AMENDMENT OF SOLICITATION/MODIFICATION OF CONTRACT

8. NAME AND ADDRESS OF CONTRACTOR (No., Street, County, State and Zip Code)			
		X	9A. AMENDMENT OF SOLICITATION NO. W917PM-07-R-0086
		X	9B. DATED (SEE ITEM 11) 12-Jul-2007
			10A. MOD. OF CONTRACT/ORDER NO.
			10B. DATED (SEE ITEM 13)
CODE	FACILITY CODE

ANA Garrison K-Span Kunduz

1. Delete Section 00010 Proposal Schedule in its entirety and replace with the attached revised Section 00010 Proposal Schedule.
2. Delete Section 01010 Scope of Work and replace with the attached revised Section 01010 Scope of Work.
3. Changes to Drawings: The solicitation omitted design drawings Volume 2 and Volume 3. The omitted drawing are included as part of this amendment.
4. Deletlet Section 001015 Technical Requirements and Replace with revised Section 001015 Technical Requirements.
5. Delete Section 001321, paragraph 3.4.5 Network Analysis System and replace with Revise Section 01321, paragraph 3.4.5 Network Analysis System.

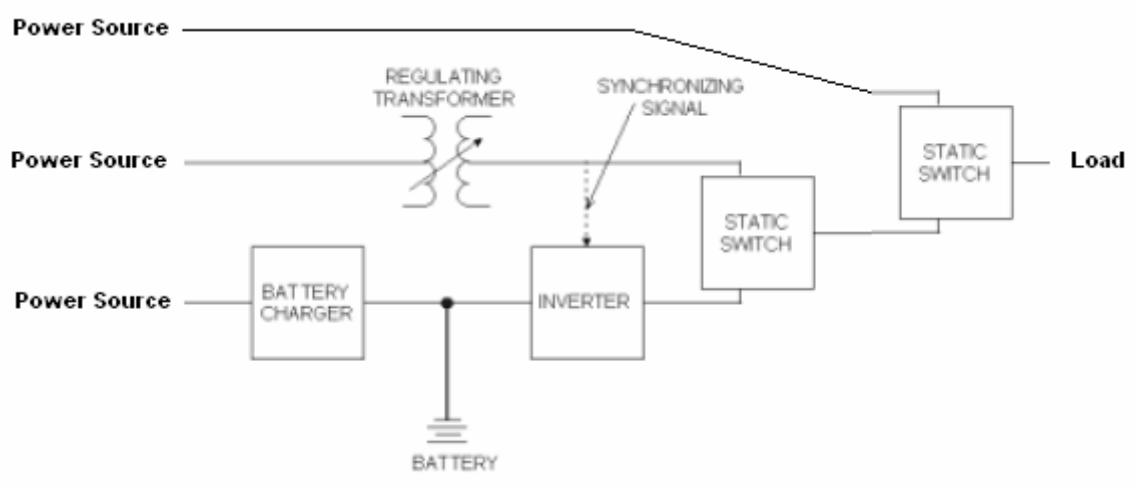
Parallel to the UPS system shall be a Regulating Transformer (aka Servo Motor Voltage Stabilizer) with a manual transfer switch. Regulating Transformer shall be of same rating as the UPS. A Manual Transfer Switch (MTS) shall be provided to bypass the UPS and instead use the Regulating Transformer.

A Manual Transfer Switch shall be provided to by-pass the UPS and Voltage Stabilizer in the event of a major problem with both units. See diagram. (Static Switch & Manual Transfer Switch are used interchangeably). Automatic Transfer Switch between base power and Communications Building Stand-by Generator are connected to the power source end of the diagram below.
